The Performance Based Operations Aviation Rulemaking Committee (PARC) is pleased to submit the following recommendation for revising design criteria relative to obstacle evaluation assessments (OEA) for Advanced RNP (A-RNP) procedures.

Introduction

FAA Airworthiness Case for Advanced RNP (A-RNP) Lateral OCS Reduction

Figure 1

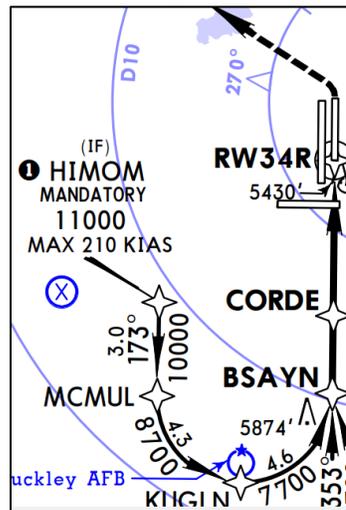
- 2) When it comes to cost, industry understands we cannot ask the FAA to support multiple approaches to the same runway without a justification. If A-RNP retains the 3xRNP OEA, this would go against this request from the FAA. Since industry intent is to try and leverage existing RNP AR procedures that could be flown without the need for AR authorization, having a differing OEA assessment would mean existing procedures would not be valid without new source and flight validation. KDEN is often used as an example of this, see Figure 1:

In this example, the procedure meets all the guidelines set forth for A-RNP but was designed and implemented with a 2xRNP OEA. The FAA could re-assess this procedure for 3xRNP but the secondary surfaces could pull in new obstacles causing a need to have an altered lateral/vertical path and therefore a new procedure with a different suffix **OR** a loss in the efficiency on the already established design. A-RNP OEA harmonization ensures existing procedures meeting the A-RNP guidelines will be quickly available for use while keeping costs down for the FAA.
